BP Cherry Point Refinery
4519 Grandview Road
Blaine, Washington 98230
Telephone 360 371-1500

August 15, 2011

Subject: Comments on Listing of Grid Cell 4812217G5_SW (Strait of Georgia) as Category 5 – Public Comment Period ending August 16, 2011 for 2010 Water Quality Assessment

BP CHERRY POINT SEDIMENT 303 (d) COMMENT LETTER 60190830-4.2		2006 SIEVED SAMPLE SEDIMENT TOXICITY TEST RESULTS	
DATE: 7/27/11	DRWN: MO/SEA	FIGURE 2

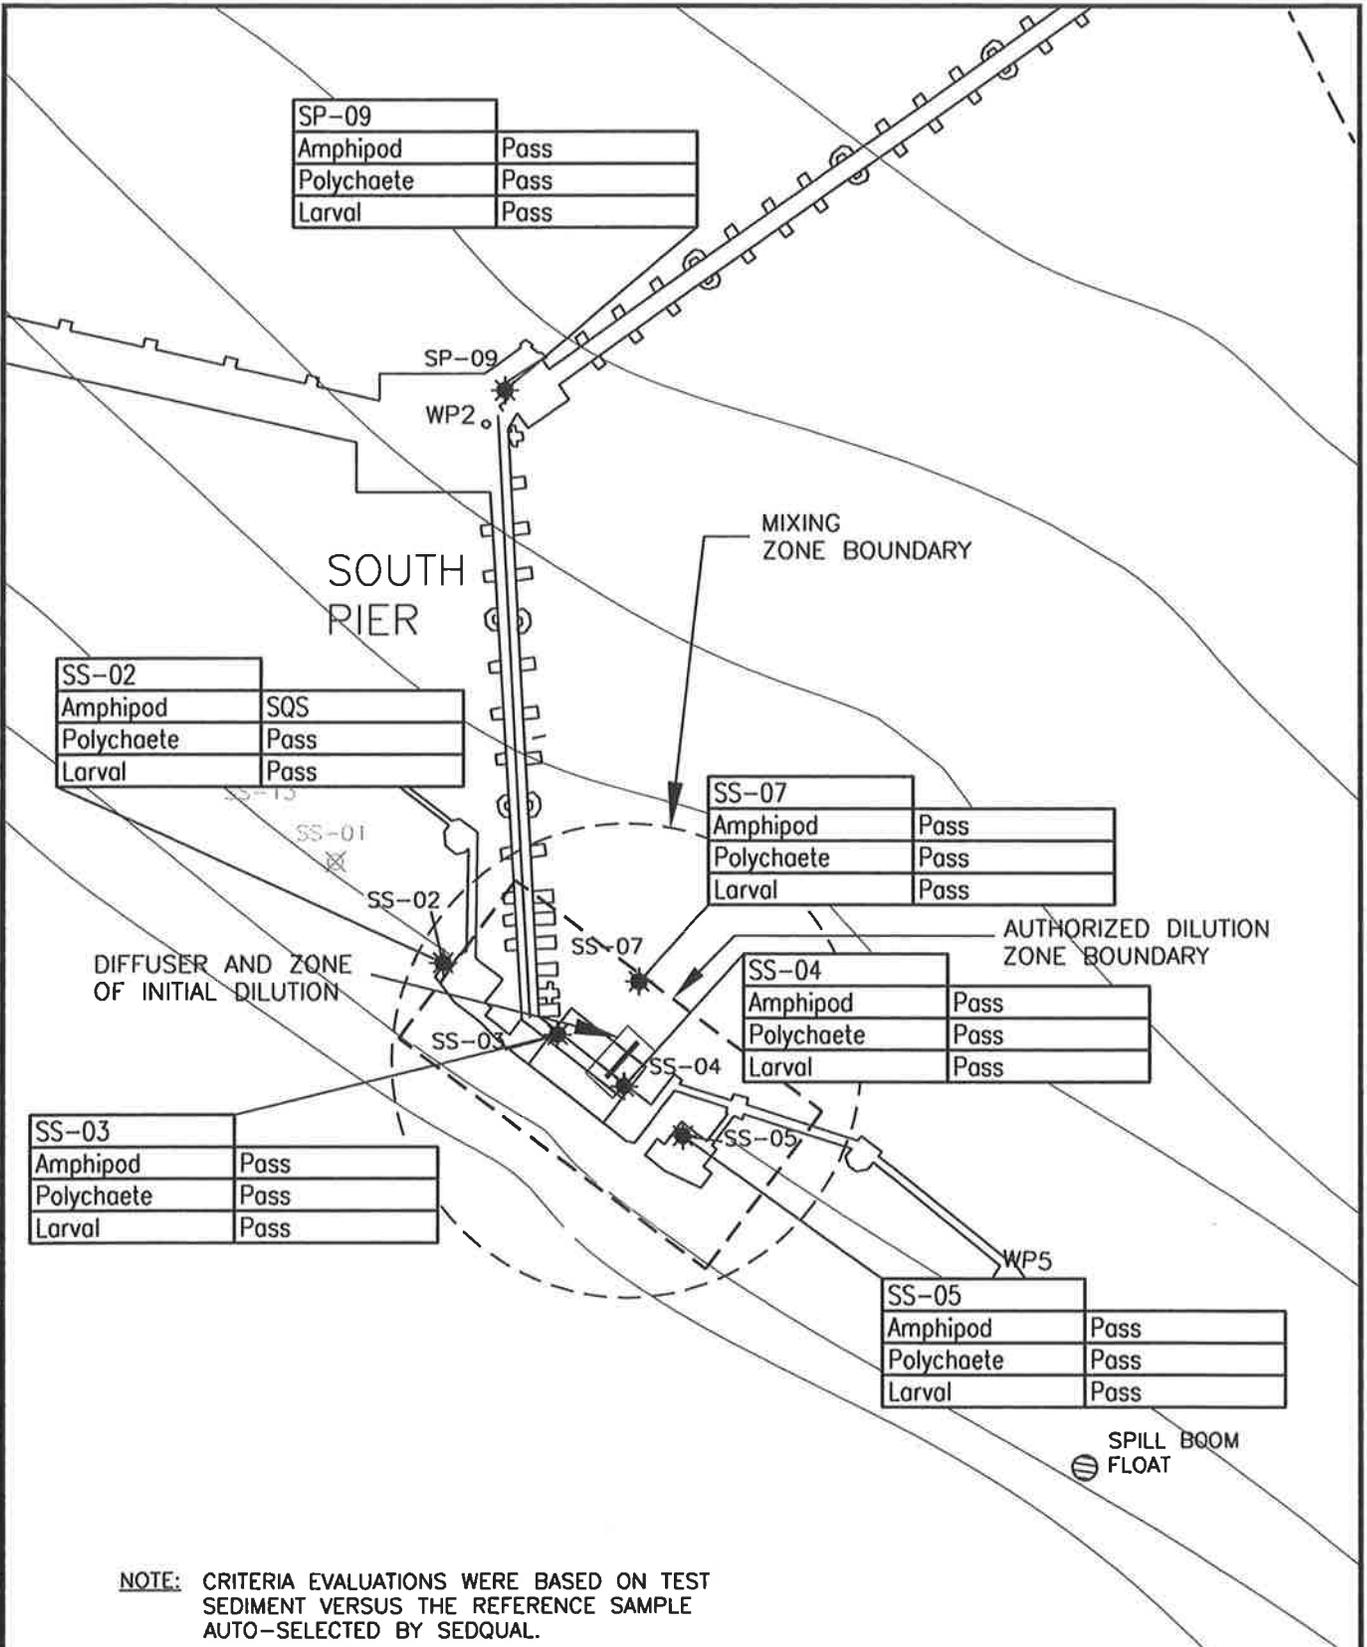
In 2000 all sediment samples passed the chemical and/or biological criteria. In 2001, sediment toxicity testing was conducted on samples SS-01 through SS-04 (Figure 2). Biological effects were observed in SS-02, SS-03, and SS-04 above CSL criteria. Sulfide concentrations and shell fragment percentages were elevated in each of these samples, and ammonia was elevated in samples SS-02 and SS-03. Sulfide and ammonia are common confounding factors that can contribute to increased toxicity. The chemical and biological exceedances observed during the 2000/2001 sampling programs did not fit the trend established in sampling programs of the previous 10 years, wherein only minor SQS exceedances occurred (RETEC 2007)².

Because the presence of shells, and not the chemical quality of effluent, was believed to be responsible for the 2001 bioassay failures, sample locations were re-characterized in 2006 on six sieved (shells removed) sediment samples. Sediment toxicity tests on these sediment samples had a single SQS failure for the amphipod test at station SS-02 (Figure 2). This station had a high percentage of fines (36 percent), and the interstitial sulfide and ammonia measured during the toxicity test exceeded published thresholds. The amphipod *Rhepoxynius abronius* is sensitive to both high percent fines and elevated sulfide. These confounding factors likely played a role in this failure, particularly because this sample had the lowest total polycyclic aromatic hydrocarbon (PAH) concentration of the under-pier samples (7.1 mg/kg dw). Toxicity tests for the sieved sediment samples with elevated sulfide concentrations in porewater (>10 ppm), were also conducted on a replicate sample in which sulfides were controlled. When controlling for sulfides, all stations including SS-02 passed SMS biological criteria (RETEC 2007).

We believe that the most recent data (2006) should be used for making sediment quality assessments, given that the 2001 data used in this proposed 303(d) listing are over 10 years old and that the newer (2006) data from re-occupied stations show minimal toxicity exceedances. Grid cell 4812217G5_SW should be listed as Category 1. The sediment in this grid cell will be analyzed periodically as part of BP's NPDES permit renewal process. There have been no new data collected since 2006 that would warrant a change from the 2008 303(d) designation as Category 1 (Attachment 1).
